Project: Graff Residence
3 Middle Patent Road
Tax ID: 95.03-1-52

RE: The Graff Residence
3 Middle Patent Road
95.03/1/52

Please see our following responses from the Planning Department Staff Report, dated 1/14/21 and Kellard Sessions Consulting Memorandum, dated 1/21/21.

Drawing Number:
S-1

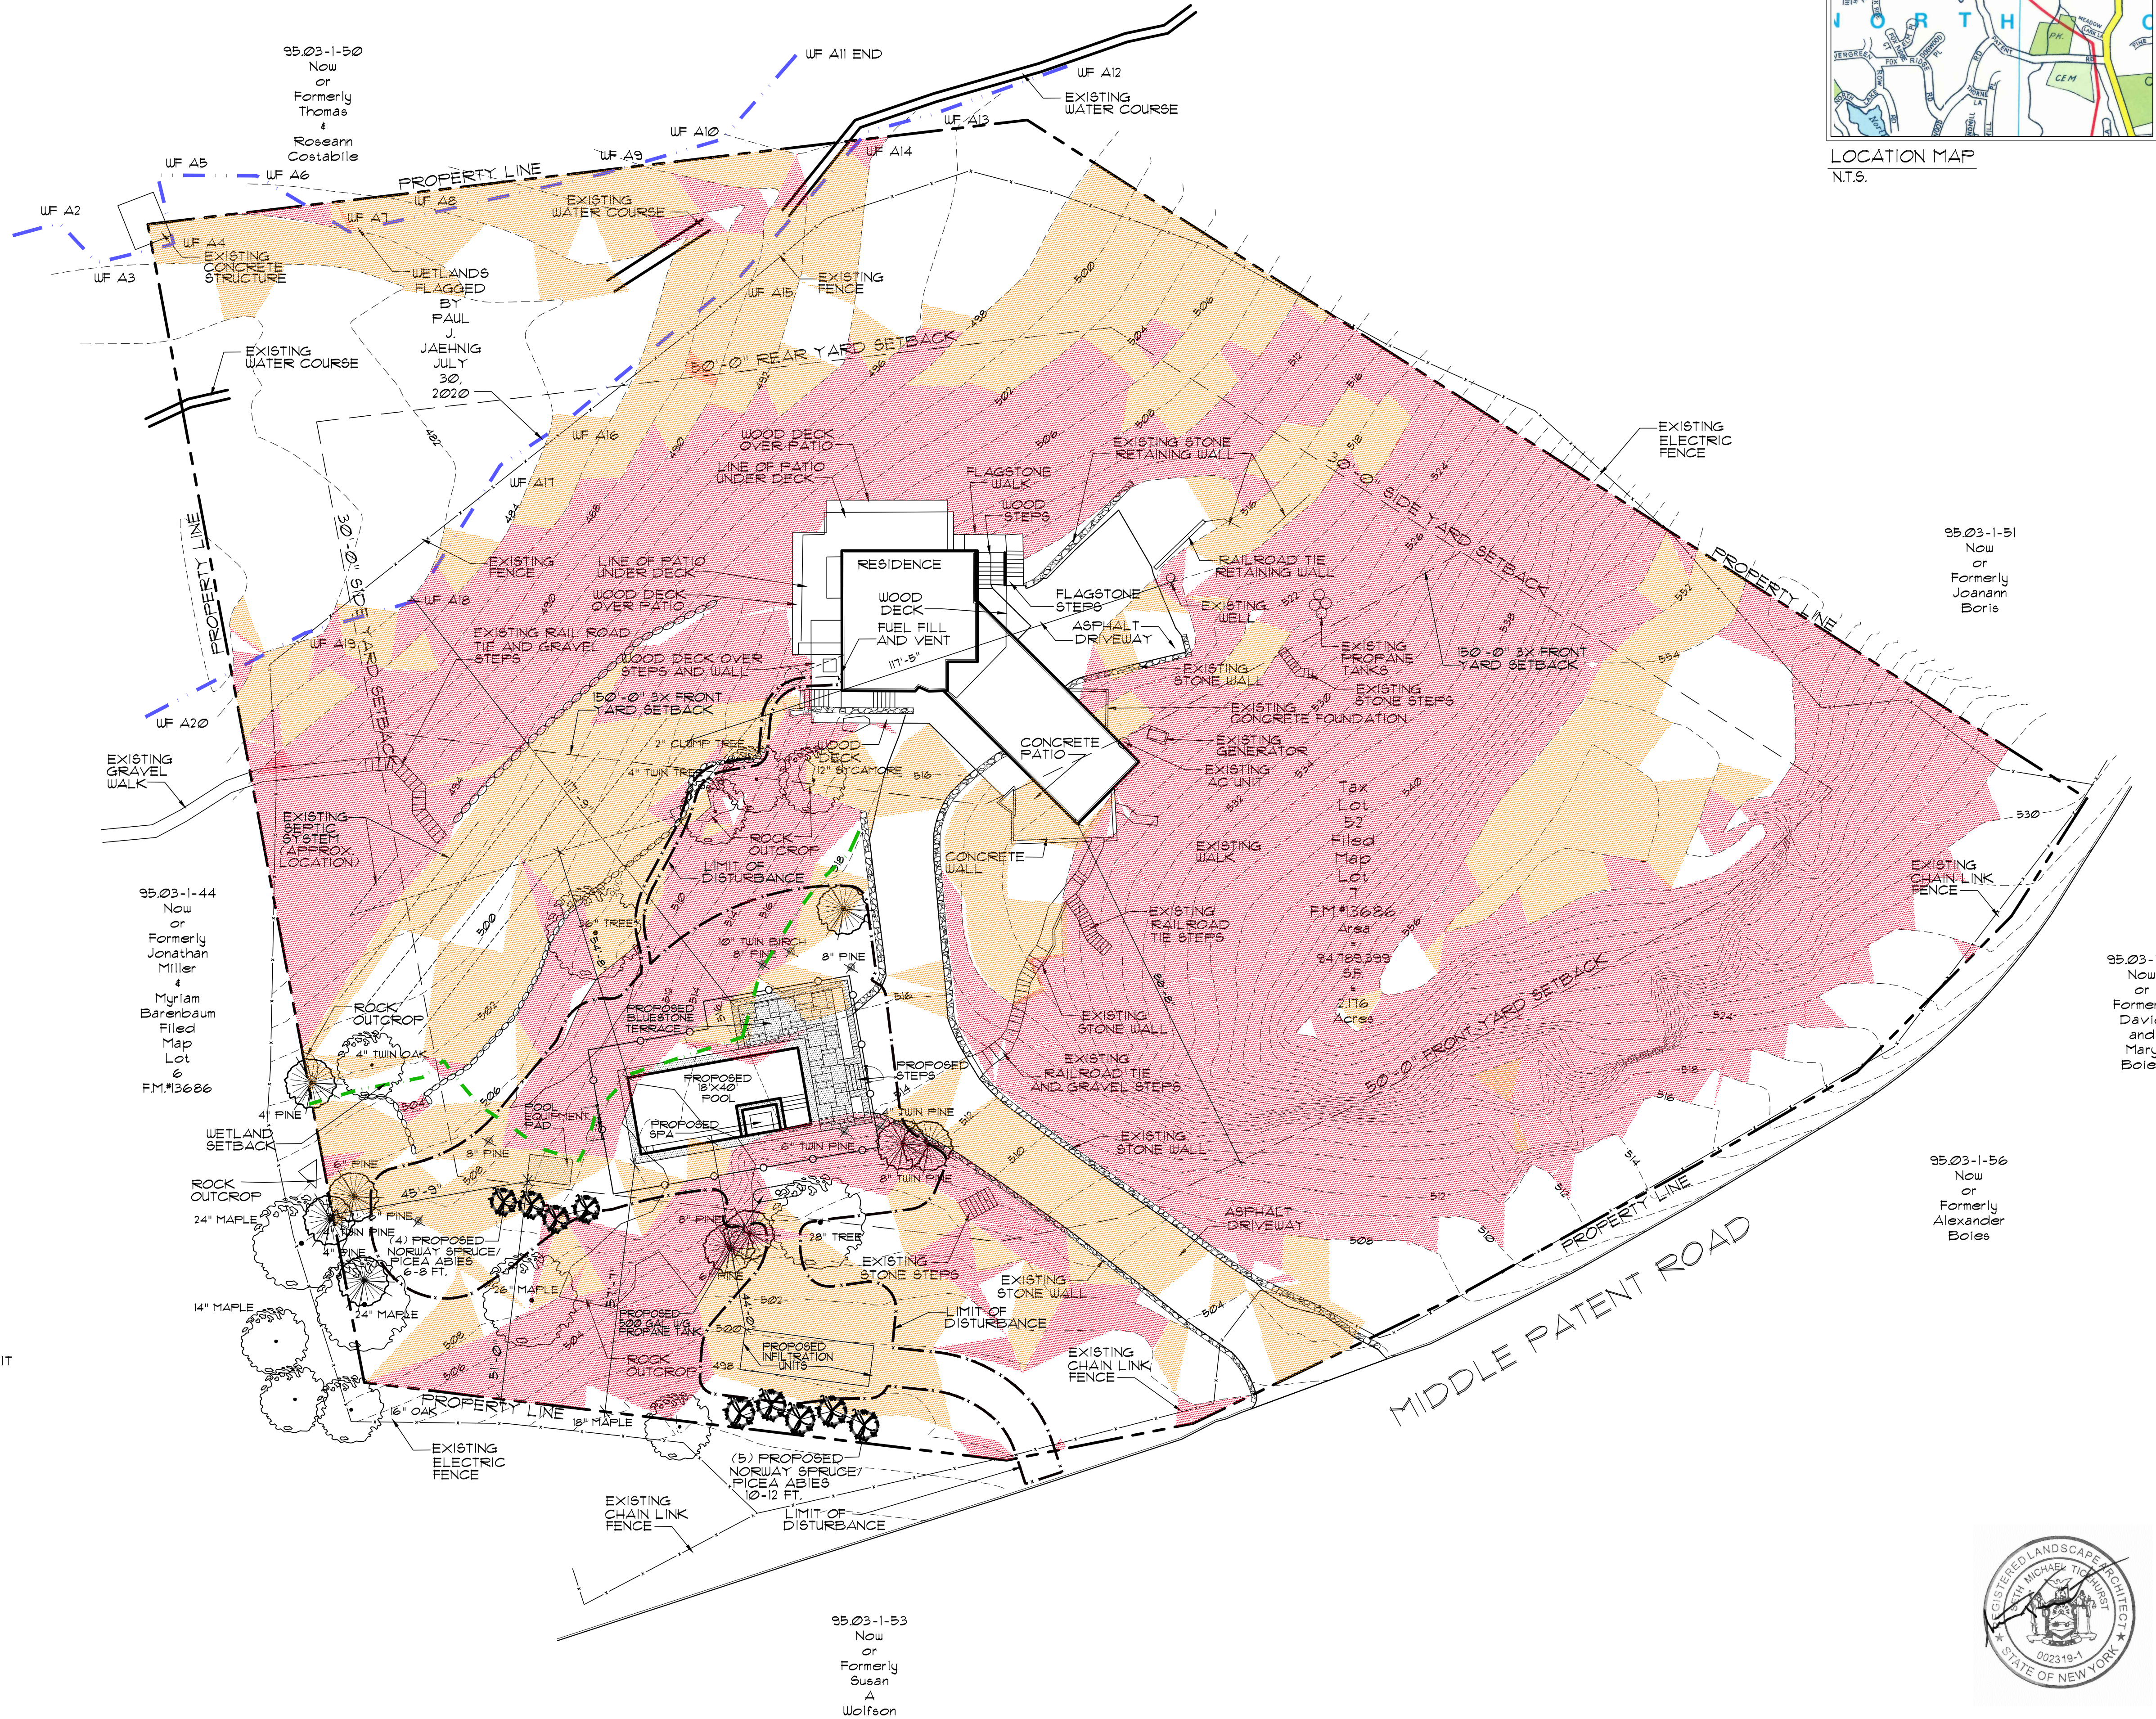
6. The separation distances between the existing septic system and well and proposed stormwater mitigation system and pool are now dimensioned and illustrated on the Site Plan/ Steep Slopes Analysis.

7. All trees to be removed are shown and listed on the Site Plan/ Steep Slopes Analysis and Preliminary Pool Location Plan.
8. Construction details, including the concrete equipment pad, are shown on the Details sheet, by Benedek and Ticehurst, and Construction Details sheet, by Provident Design Engineering.

TITLE: **STORMWATER MITIGATION PLAN**

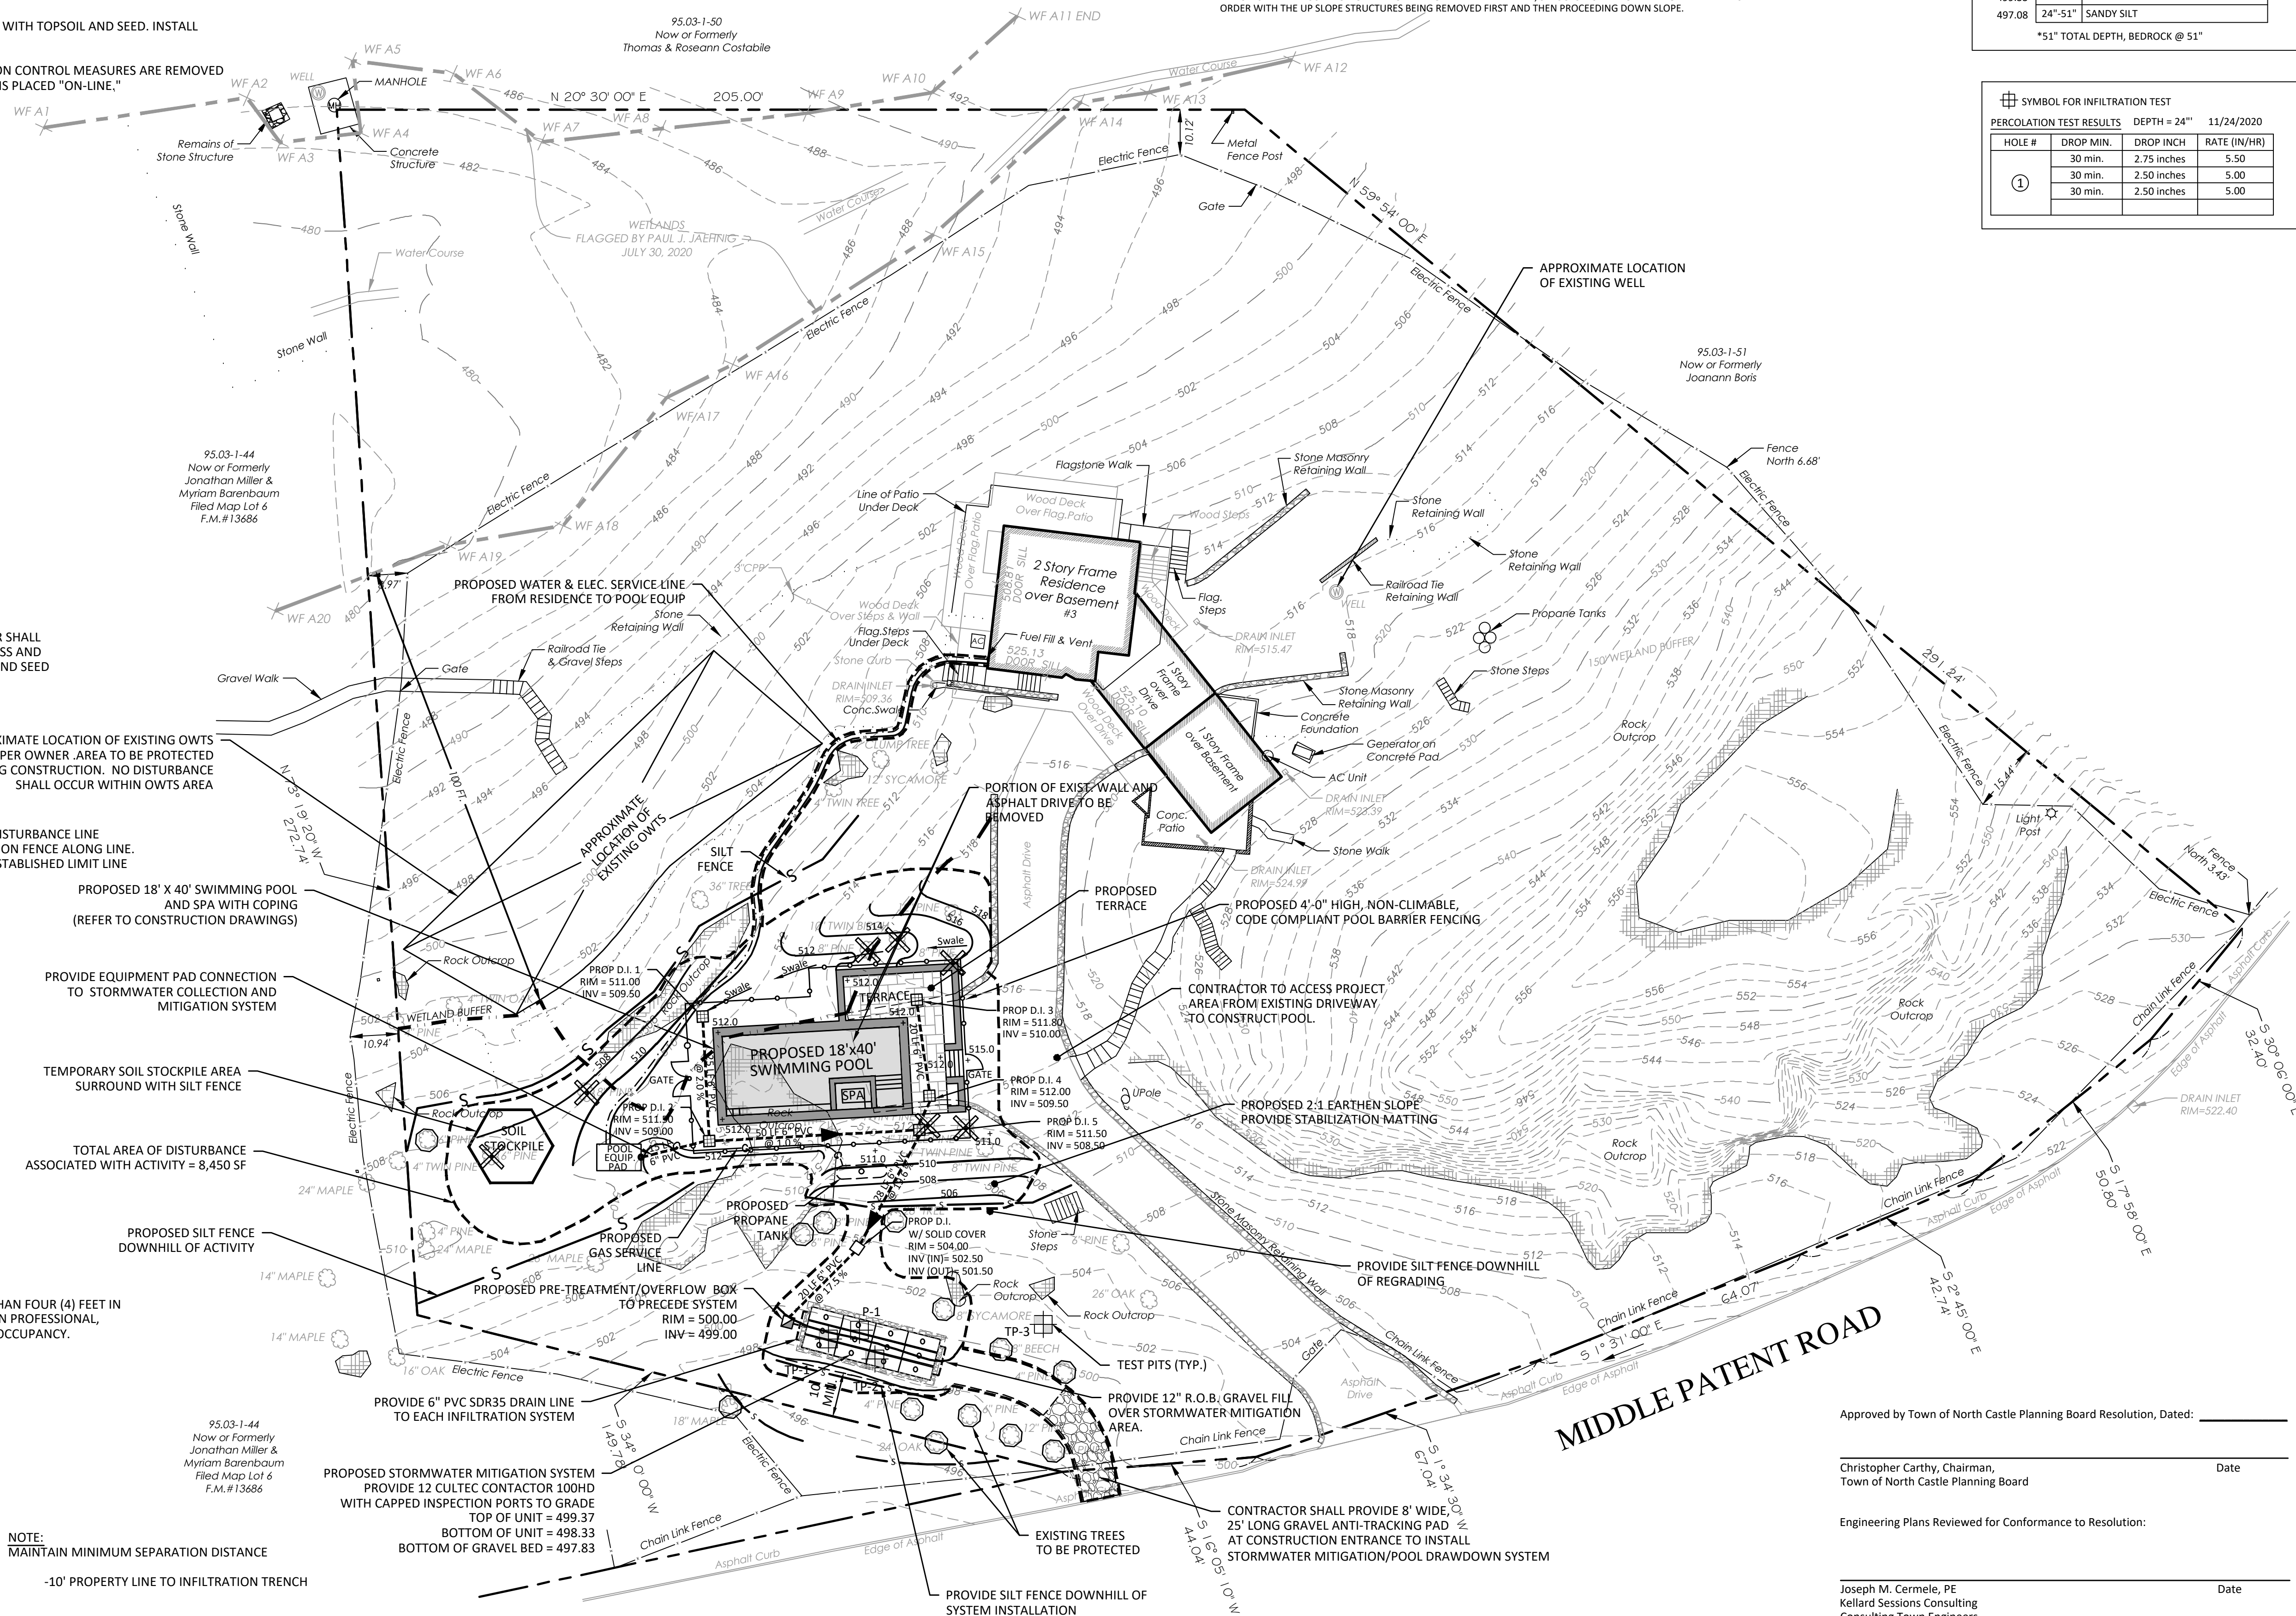
5. The Stormwater Mitigation Plan, by Provident Design Engineering, has been updated to show the connection between the pool equipment and the proposed drawdown mitigation practice.
